Proposed amendments to the Drawings:

M72-135694M/MTV
Amendment dated 02/05/2004

Reply to office action mailed 09/06/2003

FIG. 4

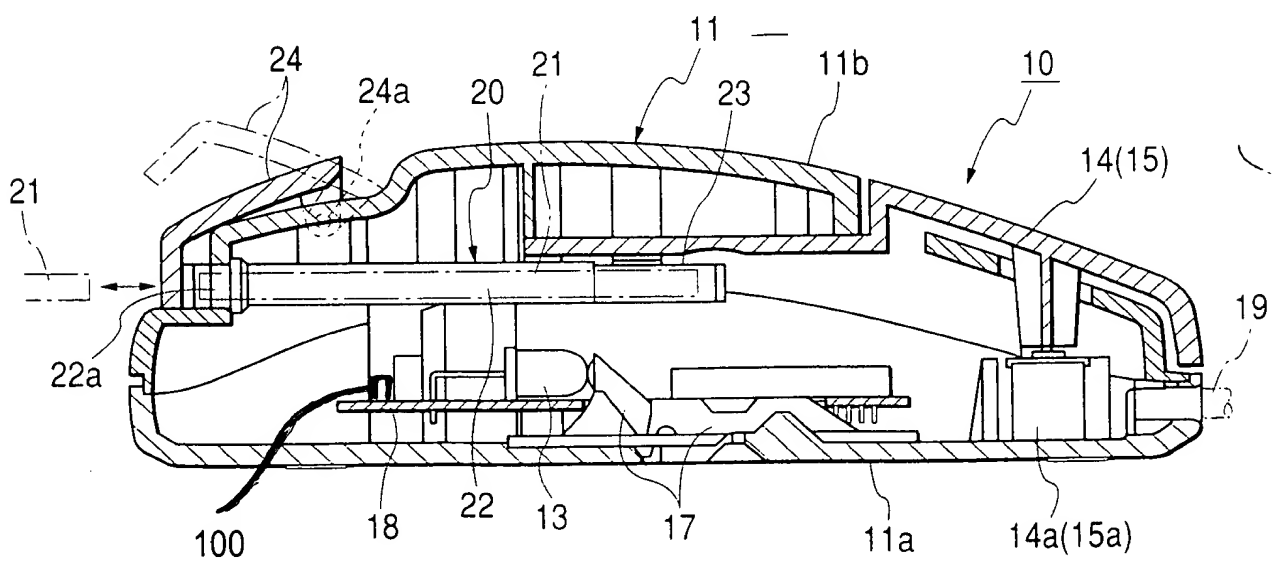
Figure 4 is amended to include a generalized box 100 on the board 18 for identifying a data processor. The specification has been amended below to include the numeral identifier 100.

medium 21 therein. Therefore, the data processor 100 is shown as a generalized box 100 on the board 18; however, it is clear from the specification that it could be located elsewhere and that the board 18 could be eliminated.

~~Not~~ Approved by *Danndt Kupper*
